City of Poughkeepsie
Planning Board
Meeting Agenda

Common Council Chambers
Tuesday, September 24, 2024
6:00 PM

1. **LOT#151783 SOUTH HAMILTON STREET: SITE PLAN**
   An application for a three-story building consisting of 29 one-bedroom units and 29 two- bedroom units. Owner/Applicant: O'Neill Group Hamilton LLC.; Consultant: Arico Associates; Grid # 6161-30-151782; Zoning District: Medium High-Density Residential (R-4); File #2023- 041

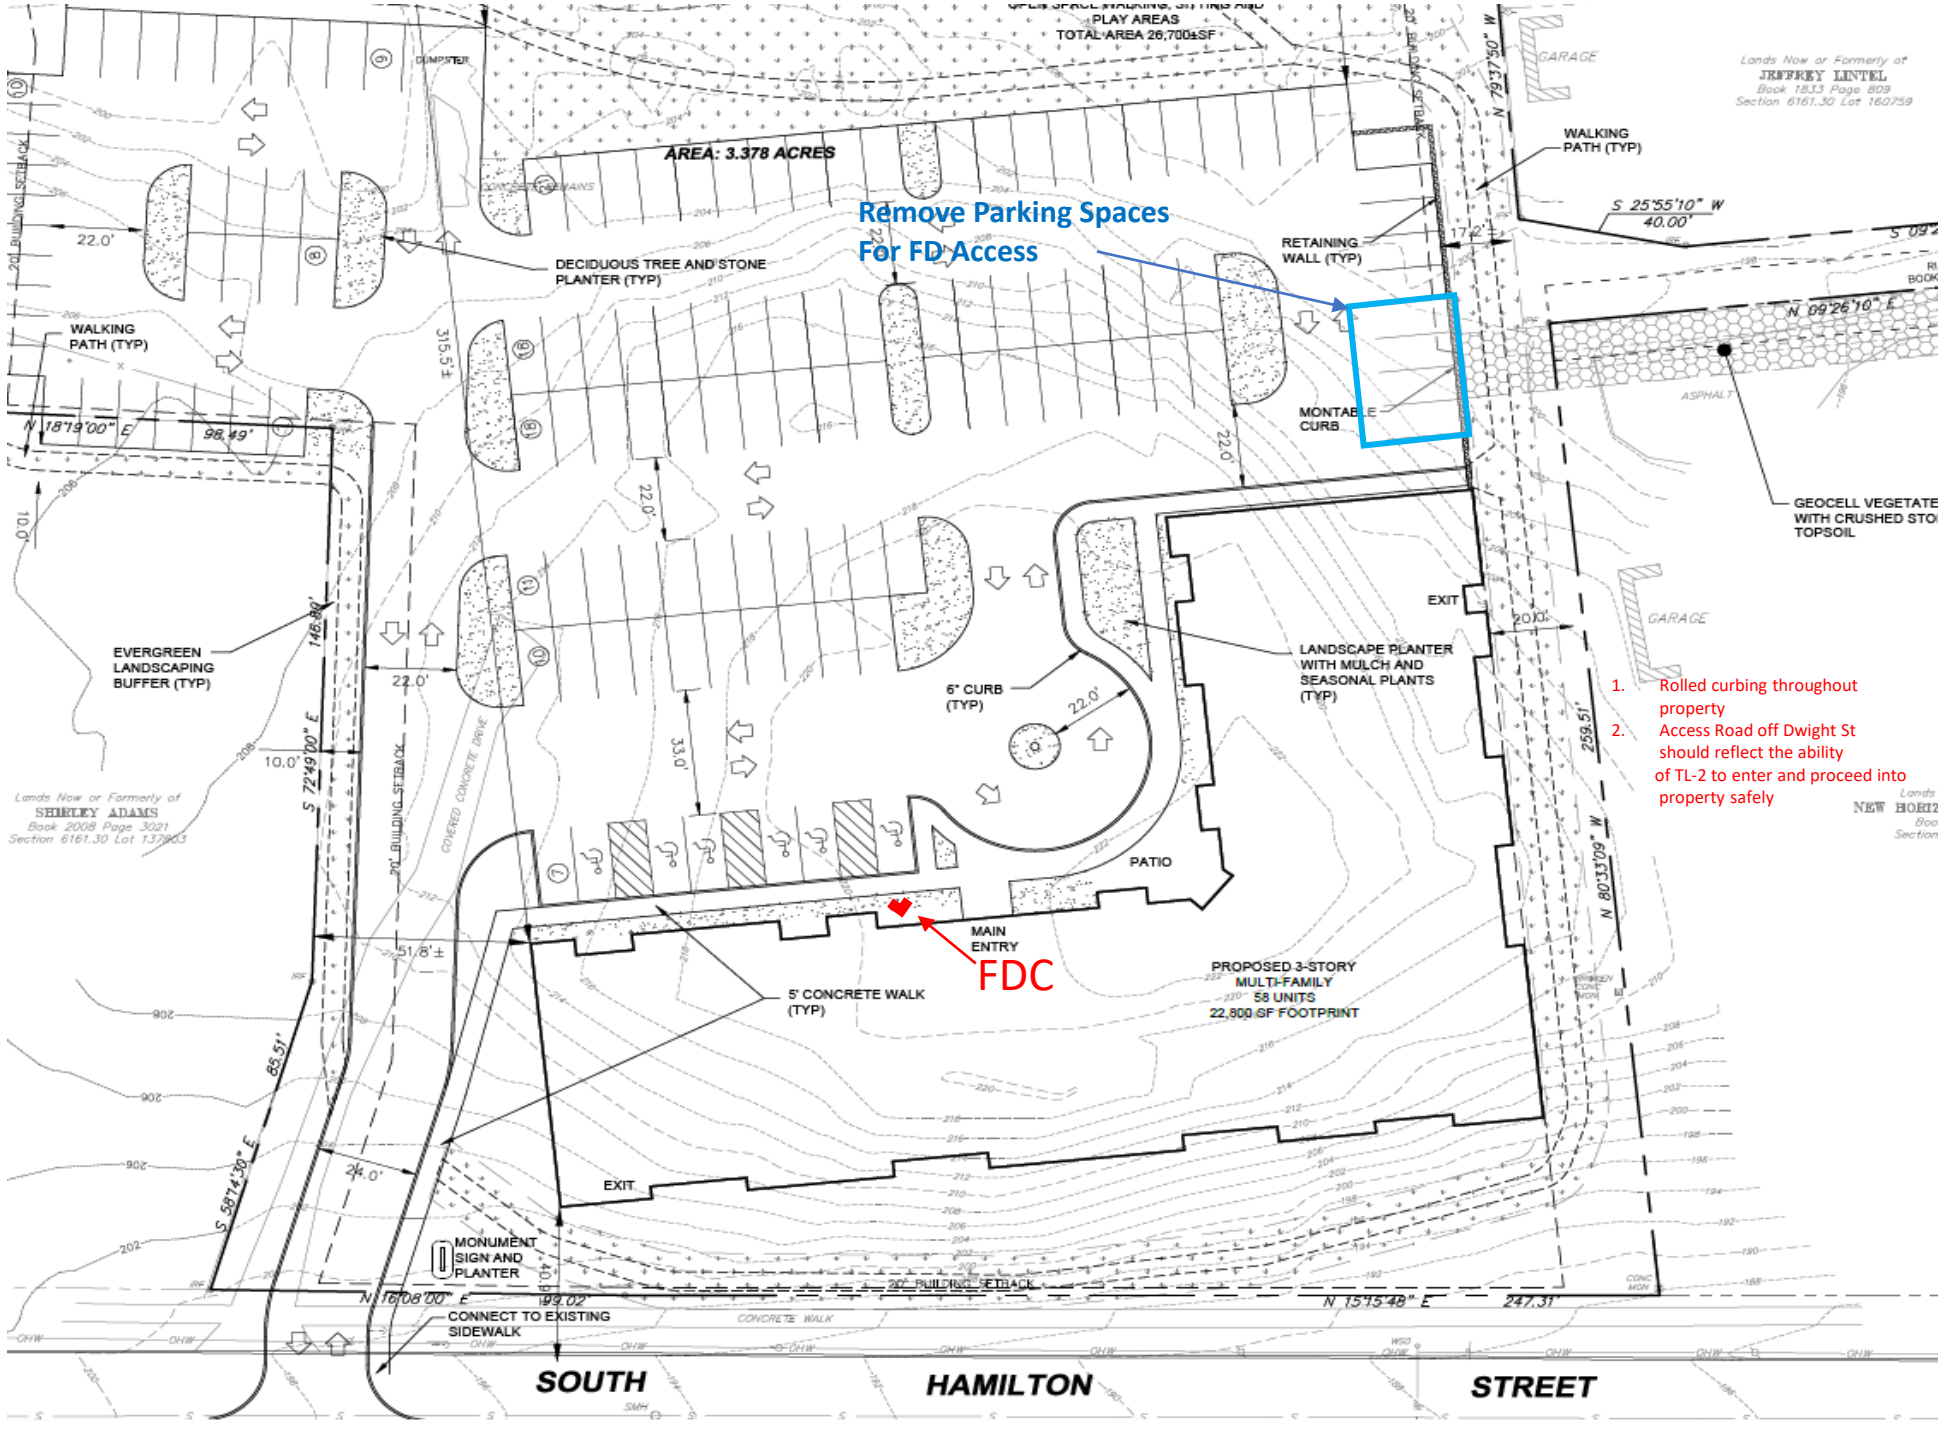
1. *The 10-year and 100-year storms peak within the subsurface detention chambers at an elevation exceeding the finished grade at the northeast corner of the property and is therefore susceptible to overflowing via the connected inlet pipe and overflowing to adjacent properties.* **This is a correct assumption and the design has accommodated for the overflow of the inlet. Though not previously shown, there is a backflow preventor (flap gate) located in STMH3 that will prevent the water levels in the sub-surface storage pipe to backflow towards the inlet at the northeast corner of the site. The design intent is to allow for this water to pool, as it previously does, and be released over time as the sub-surface storage is released through STMH4.**

2. *Consider pretreatment prior to the detention chamber or provide easier access for maintenance of deposited sediment within the detention chamber, specifically in the vicinity of the proposed inlet pipes.* **Sumps are shown for all CB structures to provided for settling of solids. The subsurface pipe, outlet control pipe and JellyFish will have monitoring and cleanout manholes for maintenance.**
